II. Responses to Comments

A. Introduction

B. Matrix of Comments Received on the Draft EIR

Figure II-1
 Mobility Hub
 Conceptual Plan Layout

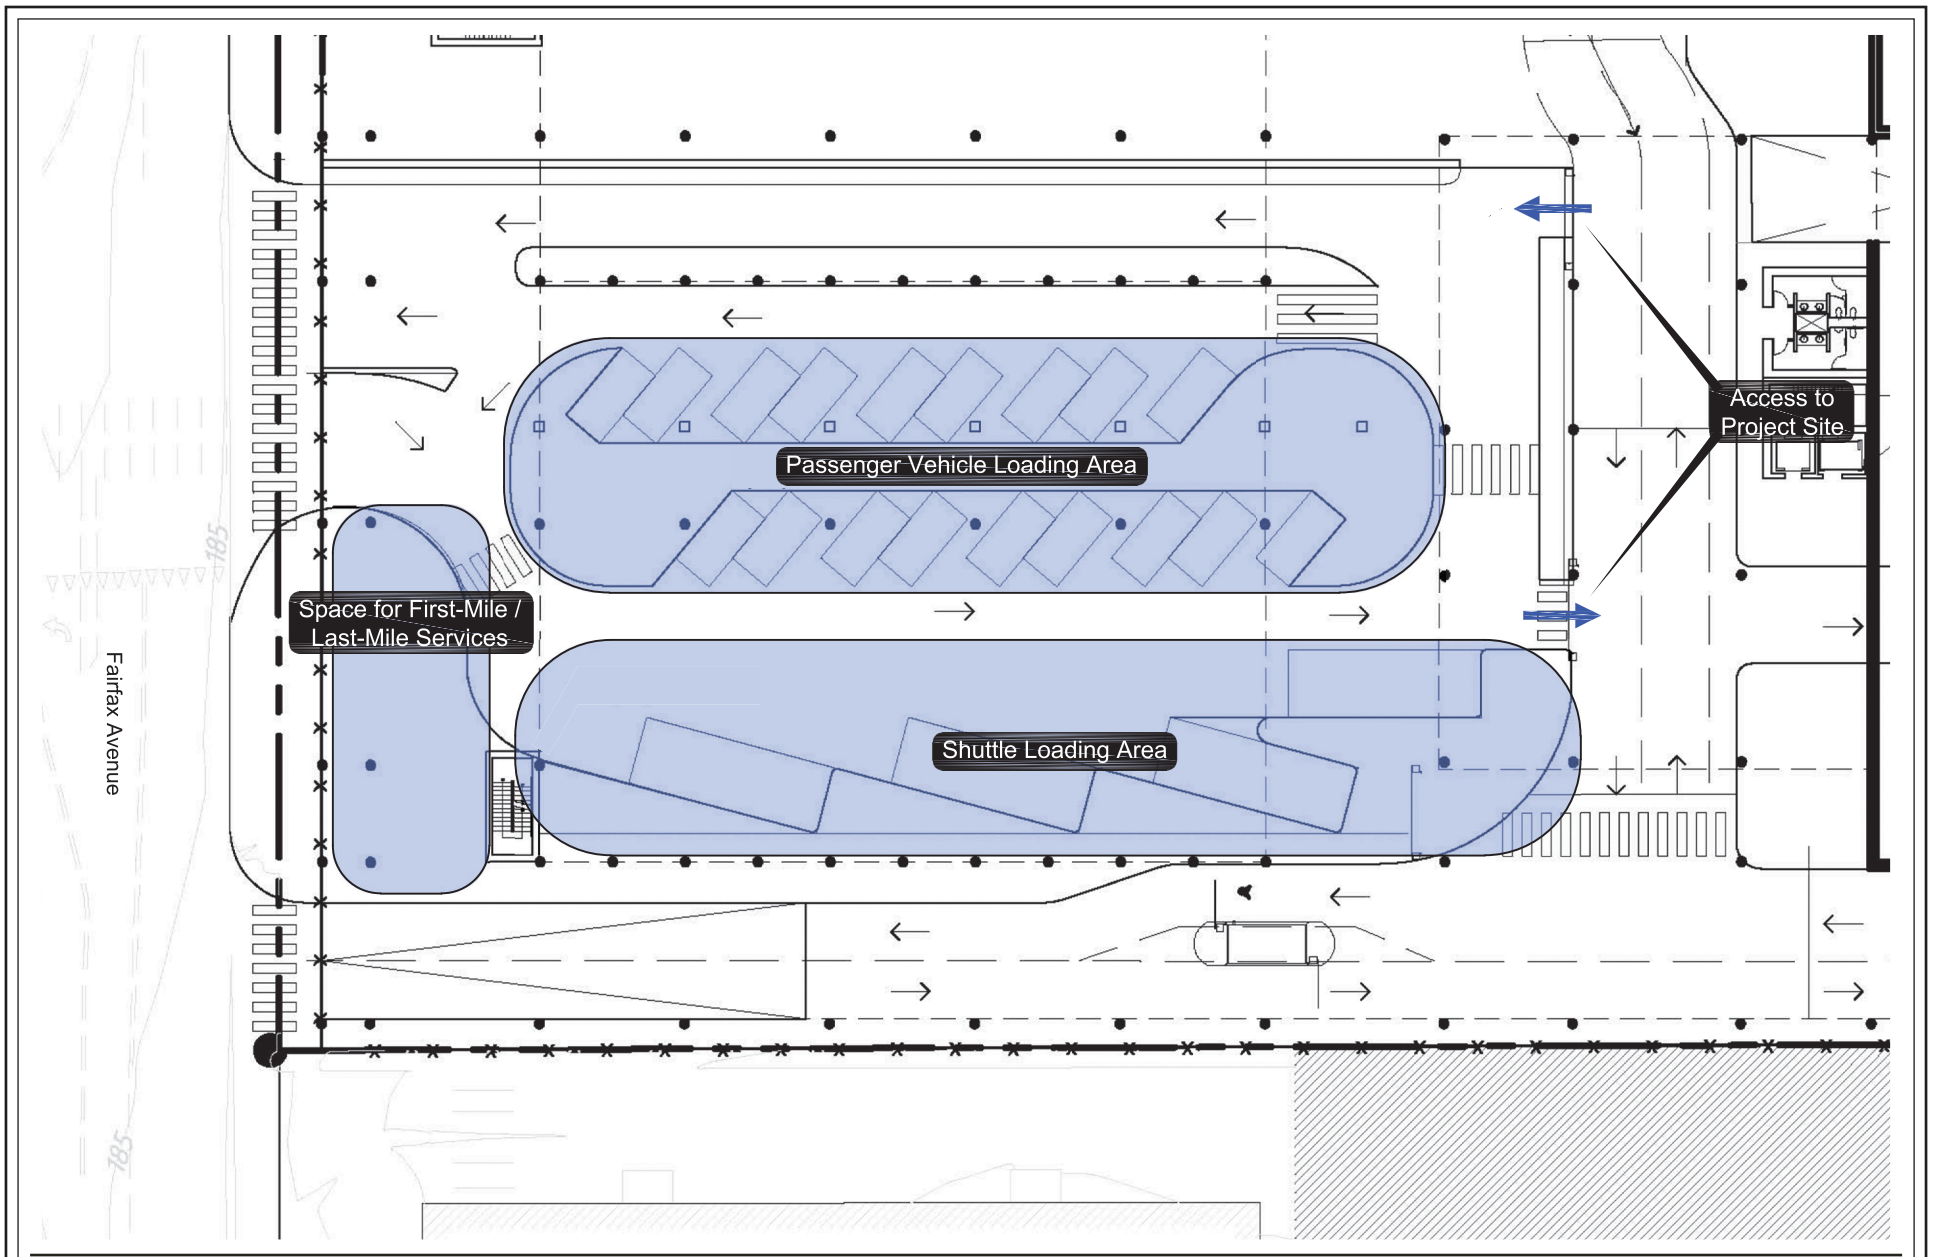
Commenters expressed concern about potential noise impacts from the Mobility Hub on adjacent properties. However, the primary Mobility Hub in the southwest portion of the Project Site is intended to be located on the ground floor of a sound stage or office building within the building envelope which would greatly minimize any noise impacts. Figure II-2 shows the location of the proposed Mobility Hub on the ground floor of an office or stage building. The Mobility Hub itself would be partially open to the outside with driveways and pedestrian connections from the Fairfax Avenue sidewalk and from the Project Site into the Mobility Hub. The Mobility Hub would be located at the grade level of Fairfax Avenue with

Figure II-1, Mobility Hub Conceptual Plan, on page II-110 shows the layout of the at-grade Mobility Hub on the Project Site immediately adjacent to the intersection of Fairfax Avenue and 1st Street. Direct access from the signalized intersection of Fairfax Avenue and 1st Street would provide entry and exit for shuttle buses and areas for visitor/audience pick-up and drop off, as well as rideshare pick-up and drop off areas. Bicycle facilities would also be provided. This design was presented in the Transportation Assessment (Appendix M.1 of the Draft EIR). Figure II-2, Mobility Hub Rendering, on page II-111 shows a rendering of the Mobility Hub as viewed from the west side of Fairfax Avenue at 1st Street. The Mobility Hub is intended to be built at the ground level along Fairfax Avenue and incorporated into the office building or stage building built above it.

Figure II-1 and Figure II-2 on pages II-110 and II-111 show the location and basic layout of the proposed Mobility Hub as well as the view of the facility from Fairfax Avenue. Figure 3 and Figure 4 on pages 14 and 15 of the Transportation Assessment (Appendix M.1 of the Draft EIR) show the pedestrian connections between Fairfax Avenue and the entrances to the Project Site. The Mobility Hub would include internalized secure pedestrian entrances to the Project Site where employees and visitors could check in through a security gate. This pedestrian entrance would connect to all the areas of the Project Site. During off-peak times, including nights and weekends, it is anticipated that gate controls and other security measures would be utilized to secure the Project Site boundary and maintain a high level of safety.

HEIGHT ZONE MAP

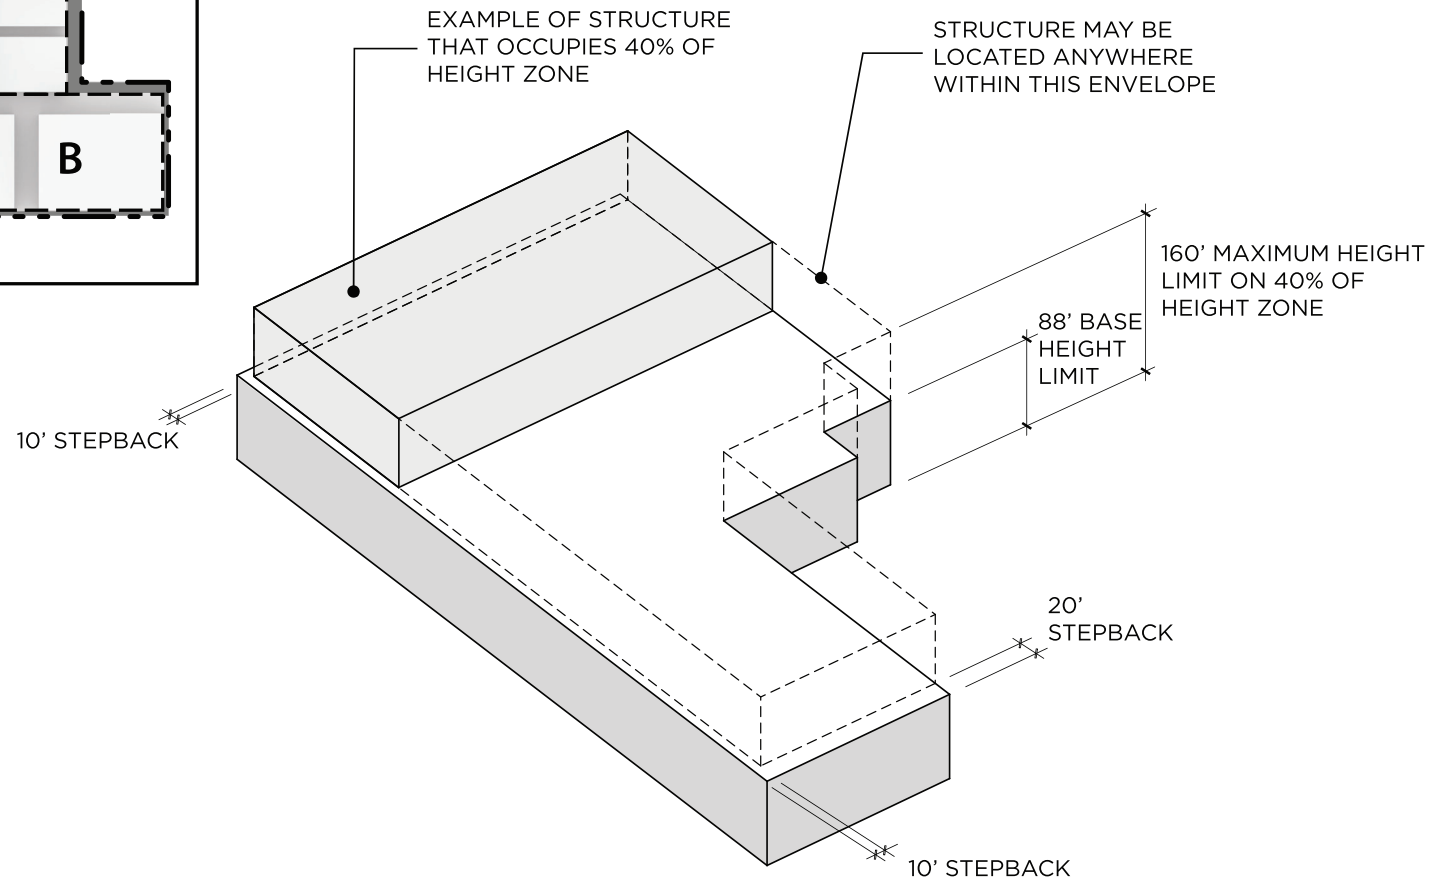
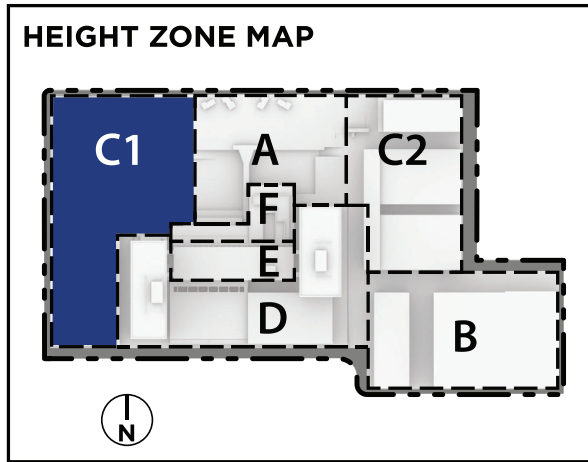
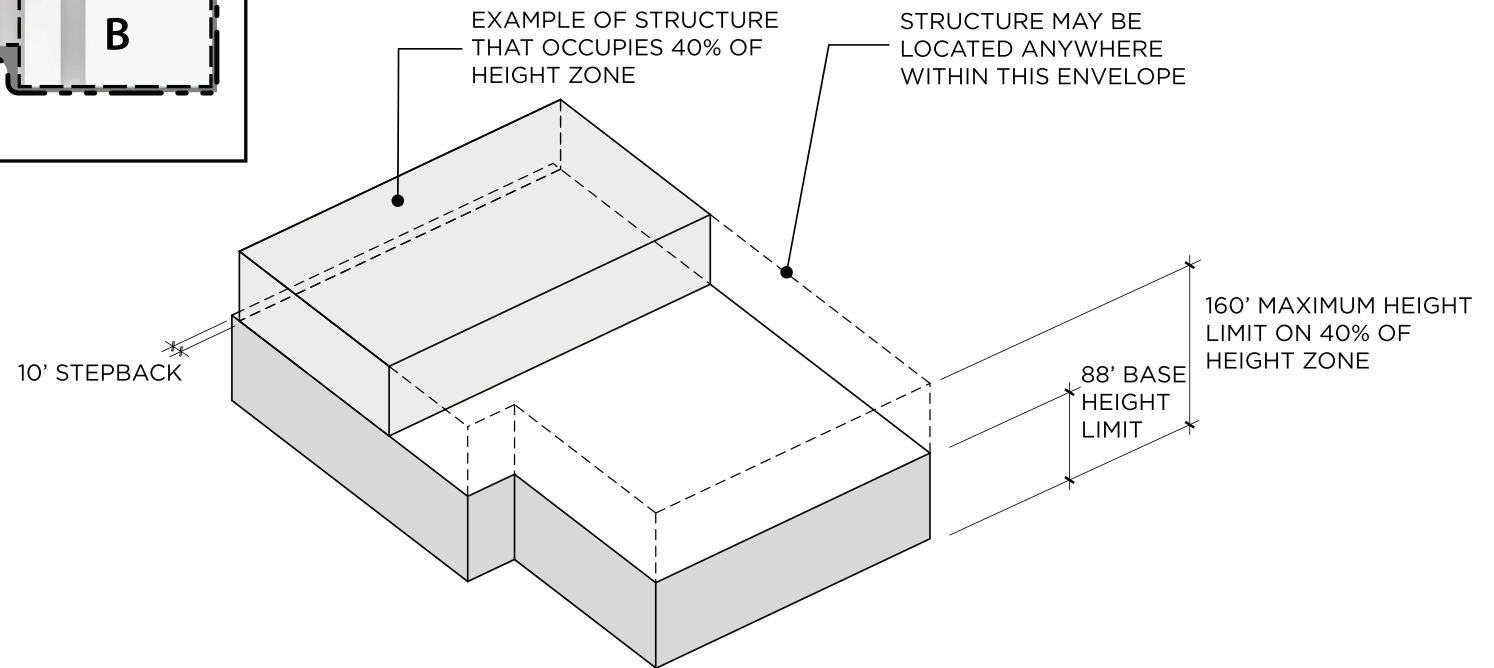
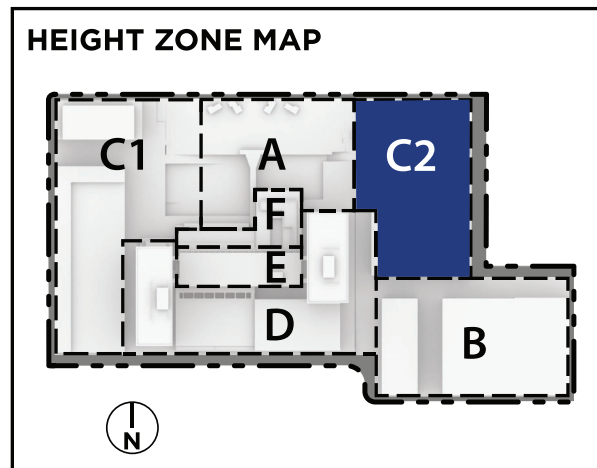
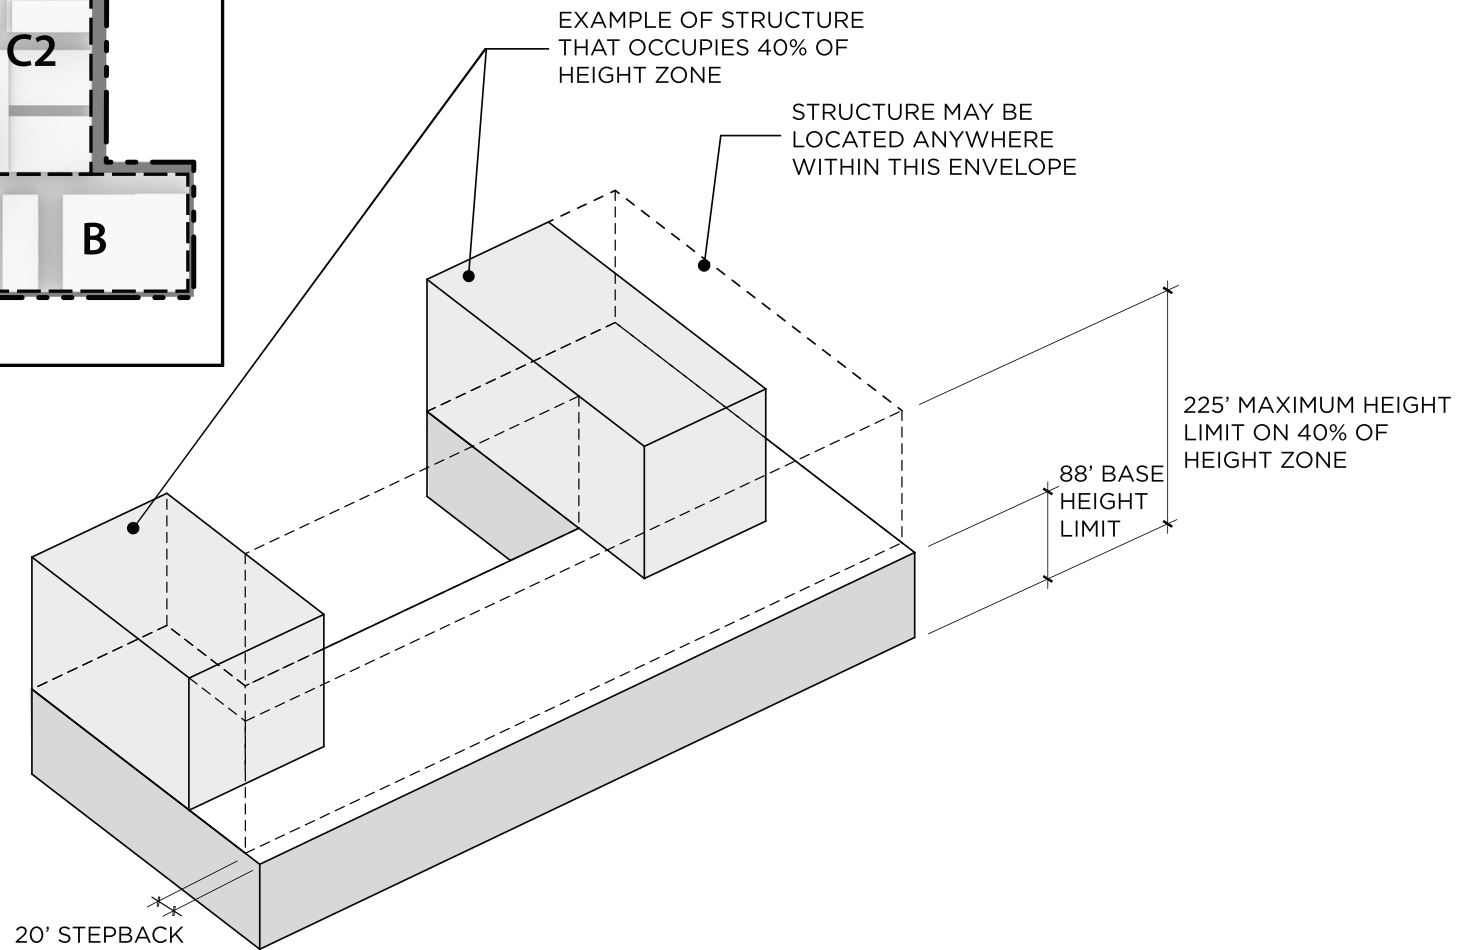
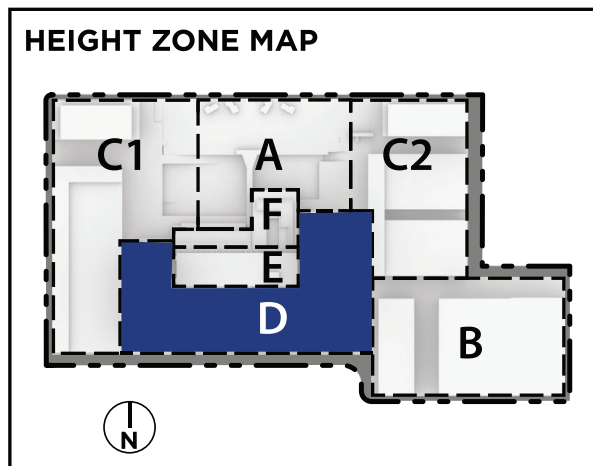
The height zones represented within the illustrations included in this comment are inaccurate and do not portray what would be allowed under the proposed Specific Plan. Refer to pages II-17 through II-20 of Section II, Project Description, of the Draft EIR for a detailed description of the proposed height zones, including Figure II-5, Height Zone Map, which are the same as the height zones included in the Preliminary Draft Specific Plan. As detailed therein, Height Zones C and D are subject to a base height limit of 88 feet. Height Zone C allows a maximum height of 160 feet within up to 40 percent of the Height Zone C area, not the entirety of the area as depicted in this comment. Similarly, the 225-foot maximum height limit within Height Zone D is only allowed within 40 percent of this height zone, not the entirety of the area as depicted in this comment. Refer to Figure II-4 through Figure II-6 on pages II-244 through II-246 under Response to Comment No. 5-5 for diagrams of Height Zones C and D and to Figures II-4(a) and II-4(b) within Section III, Revisions, Clarifications, and Corrections to the Draft EIR, for aerial renderings depicting the Conceptual Site Plan. In addition, the images in this comment do not appear to demonstrate that building heights within Height Zone A would be limited to 58 feet or accurately depict the historic viewshed corridor restriction set forth in Project Design Feature CUL-PDF-1 and in the proposed Specific Plan that codifies an existing regulation set forth in the historic-cultural monument (HCM) designation for the Project Site. Also note that the illustrations within this comment do not appear to depict the required frontage areas, including, among others, the 30-foot frontage areas between the Broadcast Center Apartments and Project buildings. Refer to Response to Comment No. 5-8 regarding the proposed General Plan Amendment to change the General Plan land use designations to a unified Regional Commercial land use designation, which was fully studied in the Draft EIR.

With regard to the height zones, pages II-17 through II-20 of Section II, Project Description, of the Draft EIR provide a detailed description of the proposed height zones, including Figure II-5, Height Zone Map. Additional figures have also been added as part of this Final EIR for informational purposes in response to public comments. Refer to Figure II-4 through Figure II-6 on pages II-244 through II-246 for axonometric diagrams and to Figure II-4(a) and Figure II-4(b) within Section III, Revisions, Clarifications, and Corrections to the Draft EIR, for aerial renderings depicting the Conceptual Site Plan. These height zones are not proposed as “illustrative” height zones. Rather, as described in the Draft EIR, these height zones set forth the maximum building height limits for all buildings within the Project Site (there is currently no height limit under the existing zone designations). New buildings would occupy only a portion of the building envelope permitted in each height zone. The height zones in the Draft EIR are the same as those in the proposed Specific Plan.

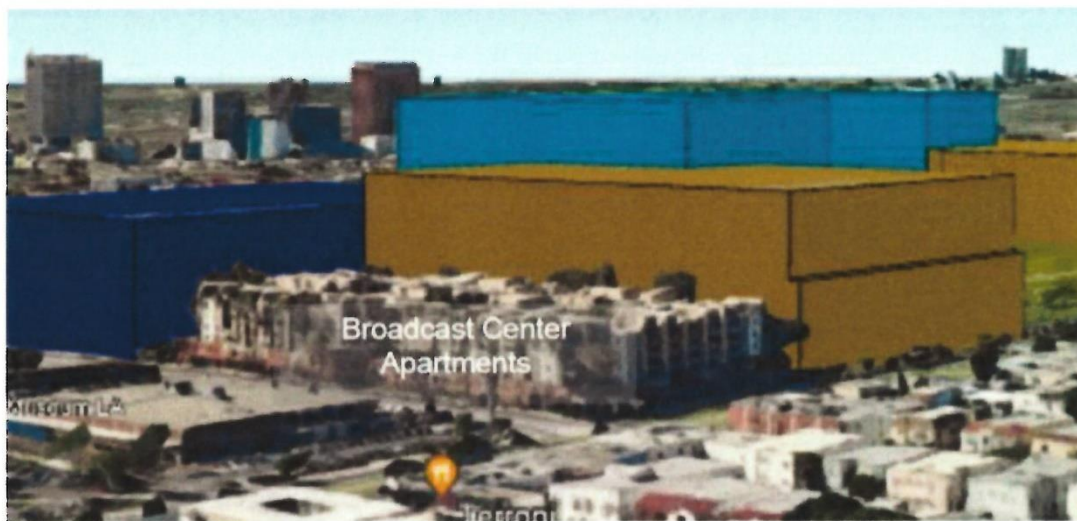
The impact to the Broadcast Center Apartments would be significant. The TVC project is reserving the right to build a 160-foot building to the east and 130-foot building to the south of the apartments. How can the impacts to these residences not be fully analyzed?

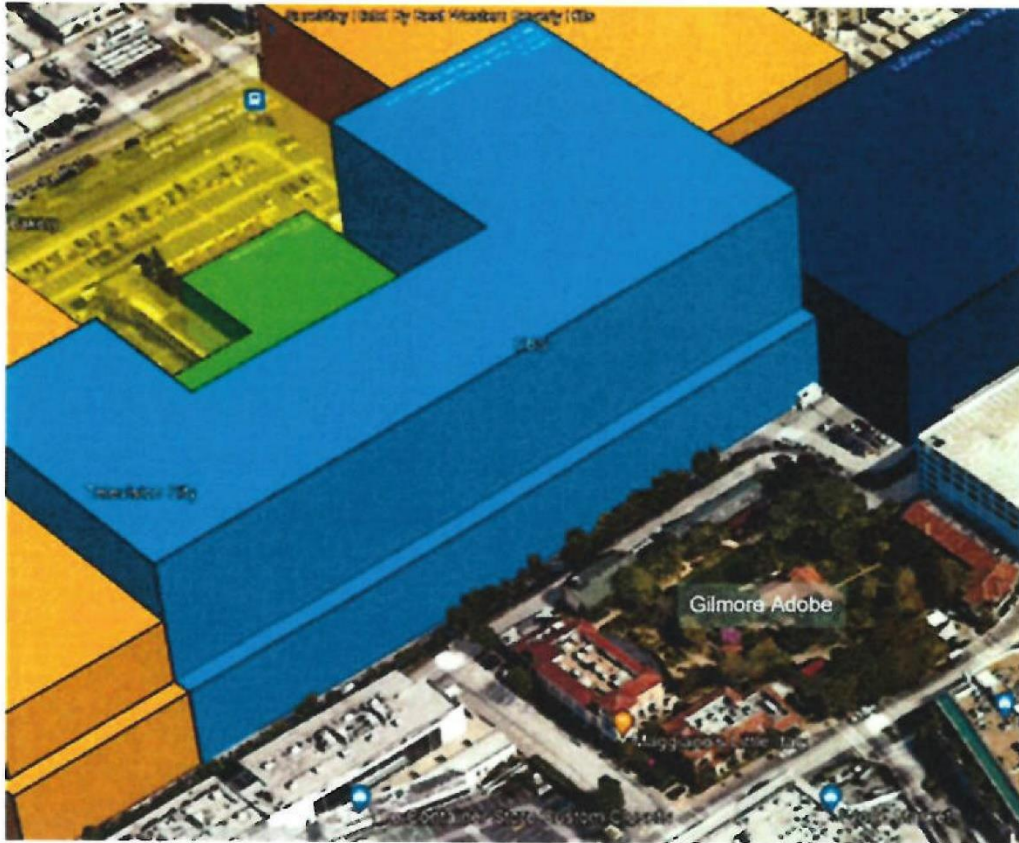
The DEIR also says the “height zones do not represent the actual development footprint of Project buildings.” The height zone figure states it is illustrative. Can a 160-foot building be built directly next to the apartment complex on the east? Can a 225-foot building be built almost directly adjacent to the Gilmore Adobe? Can a 58-foot building be built in front of the CBS Historic building as shown on the height zone figure? The maximum heights are permitted over a large portion (40%) of each of the taller height zones. Where exactly within each zone are the maximum heights permitted? Is there any further regulation of these maximum height zones? For example, what is the extent of the floor plate that could be developed to such maximum height? Absent that information, the DEIR should assume that a 160-foot tall building could be built along the entire western side of the existing Broadcast Center Apartments and a 130-foot tall building could be built along its entire southern side, significantly overwhelming this residential building as shown in the graphic below. The graphic represents the height zones. It is not a massing model. As noted below, it is virtually impossible to determine the Project's massing given the lack of information in the DEIR.

The DEIR should similarly assume that a 225+ foot tall building could be built along the entire southern frontage directly across from the Gilmore Adobe, overwhelming that historic structure as shown on the graphic below.
